Appeal of Board of Zoning Appeals Decisions Related to

Restaurant Pavilions

**Zoning File: #24-033509 (Appeal of Zoning file #24-023545)
1566 University Ave W (Temporary Address)**

F1 A - North Elevation

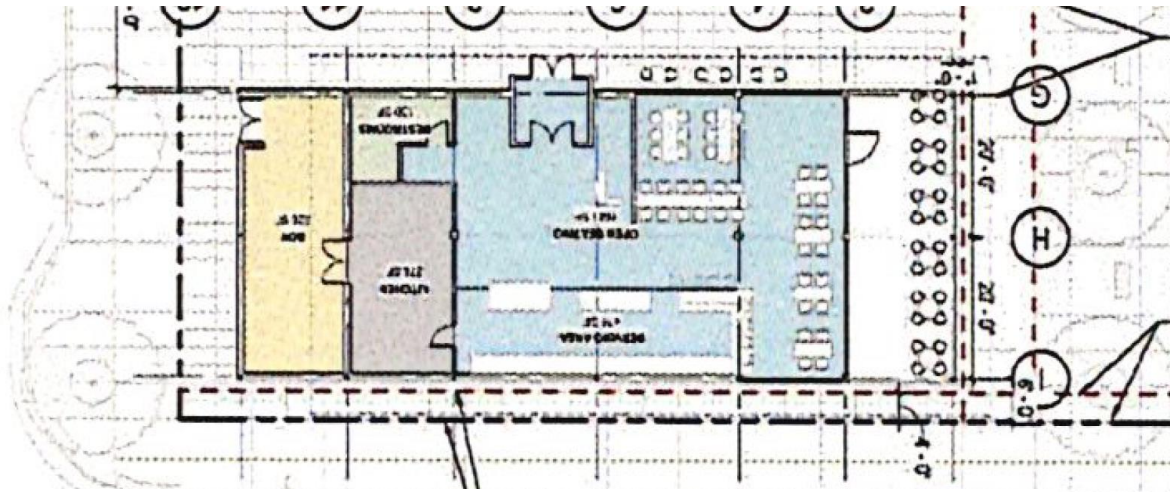
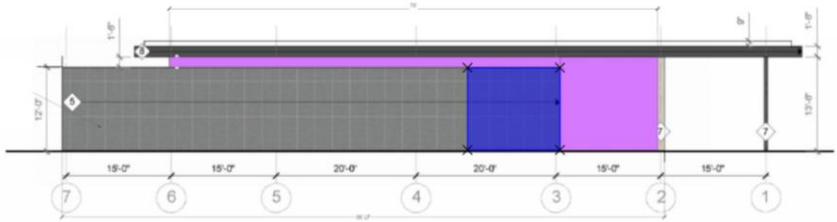
Variance #1 – Above Grade Openings (North Façade, North Bldg)

- City Council Resolution 23-1442 - 30 percent of the area along the ground floor along street facing facades required.

- Northern Façade: 19.6%, 10.4% variance

- METHODS
1. 19.6%
 2. 19.6%
 3. 71%

Dark blue box is about 153 square feet. (Size of shortage.)

North Façade – Above Grade Openings– BZA/Staff Findings in Denying Variance

3. There are opportunities to increase the window percentage to meet the requirement on the northern façade, given that the uses along the northern façade are primarily the dining room and serving area. **This finding is not met for the 19.6% request for the northern façade.**

4. The request for a variance of the window and door percentage on the northern façade seems to be self-created, as the zoning code does not prohibit windows in serving areas. **This finding is not met for the 19.6% request for the northern façade.**

BZA denied the northern façade variance request (19.6% proposed) based upon finding 3 & 4.

View from Spruce Tree

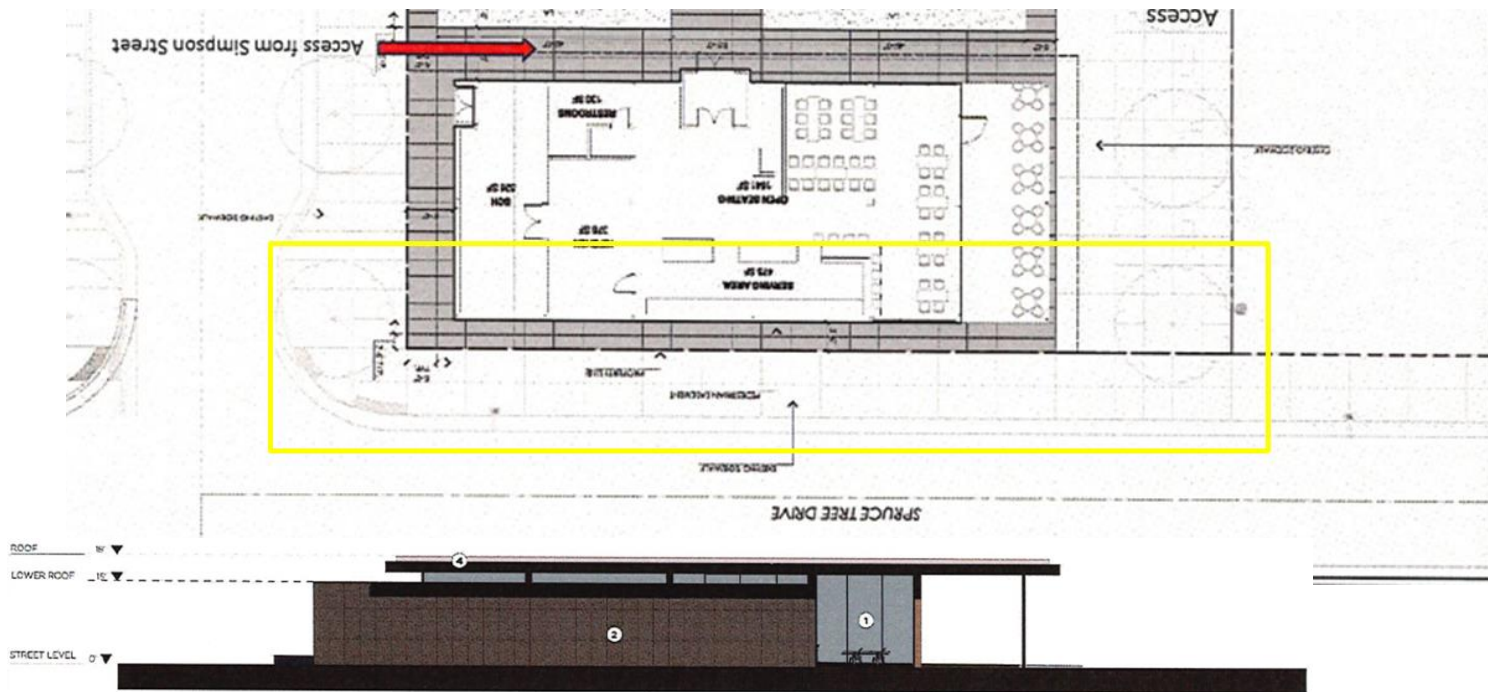
Variance #2: Primary Pedestrian Entrance

3. All new buildings within the master plan boundary must have a primary pedestrian building entrance on arterial, collector, and/or local streets.

North Façade – Primary Pedestrian Entrance Findings – BZA/Staff Findings in Denying Variance

3. Staff believe that it is possible to add a primary pedestrian entrance on the northern façade of the northern restaurant building, similar to the door on the southern entrance of the southern building into the dining room. Staff do not believe that there are practical difficulties in complying with the provision for this request. **This finding is not met for the request to omit a primary pedestrian entrance along Spruce Tree Avenue.**

4. Staff believe that the plight is self-created for the primary pedestrian entrance along Spruce Tree Avenue, as the dining room abuts this side of the building, where an entrance could be included. **This finding was not met for omission of a northern primary pedestrian entrance along Spruce Tree Avenue.**

BZA denied request to omit a primary pedestrian entrance on the northern façade based upon finding 3 & 4.

F1 A - North Elevation

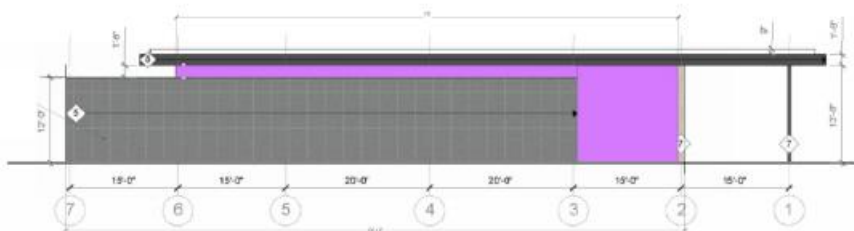
Variance #1 – Window/Door Openings

1. 19.6%
2. 19.6%
3. 71%

North Building North Facade

proportion glazed 19.6%

439 Required
153 Shortfall
